SOUTH COAST AIR QUALITY MANAGEMENT DISTRICT

Draft Staff Report

Proposed Rule 1110.3 – Emissions from Linear Generators

Proposed Amended Rule 1110.2 – Emissions from Gaseous- and Liquid-Fueled Engines

Figure 1. Mainspring Linear Generator Components¹

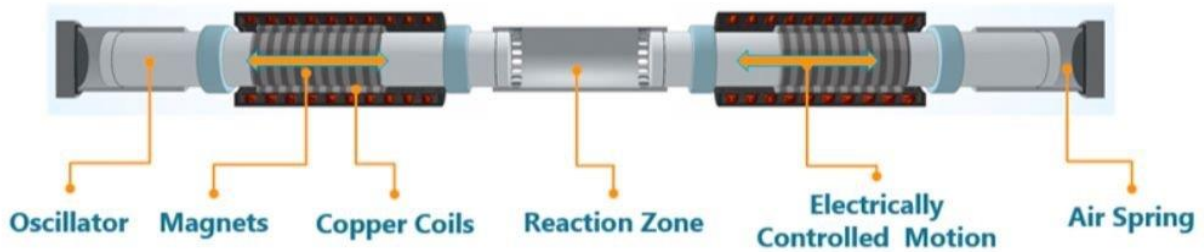
Chapter 1: Background, Page 1-1 Paragraph 2	Unlike traditional combustion engines, linear generators produce electricity by driving magnets through copper coils in a linear motion (Figure 1). In this reaction, a mixture of fuel and air are compressed, causing a chemical combustion reaction that drives the magnets through the copper coils. One of the features that makes linear generators unique is that this combustion thermochemical reaction takes place in the "reaction zone" and occurs at lower temperatures than traditional engines, resulting in lower NOx and CO emissions. Linear generators also do not utilize add-on control technologies such as selective catalytic reduction (SCR) to control NOx emissions. Although they are equipped with an oxidation catalyst, they are not dependent on this catalyst to reach a destruction temperature and thus, start-up emissions are low. As a result of the lower combustion reaction temperatures of linear generators, the oxidation catalyst's ability to control VOC emissions is limited and its main function is to reduce CO emissions. In addition, linear generators utilize a parametric monitoring system to maintain fuel and air injection proper combustion to meet energy demands. The parametric monitoring system works by monitoring and adjusting air and fuel flow to ensure proper air-to-fuel ratio is achieved, which also ensures emissions are under control. Finally, linear generators are also unique in that, based on stakeholder comments , they have the ability to operate on different fuels without any hardware changes to the equipment.	1. Linear Generators are not internal combustion engines. The use of the word "traditional" provides a comparison that is inaccurate. Therefore we are requesting removal of the word "traditional" from the staff report. 2. The reaction that takes place is a thermochemical reaction, not a combustion reaction. Please remove the word "combustion" wherever it is used to describe Linear Generator operation. 3. Linear Generators do have the ability to operate on different fuels. This statement should not be tied to stakeholder comments	5-2

Response to Email Comment 5-2:
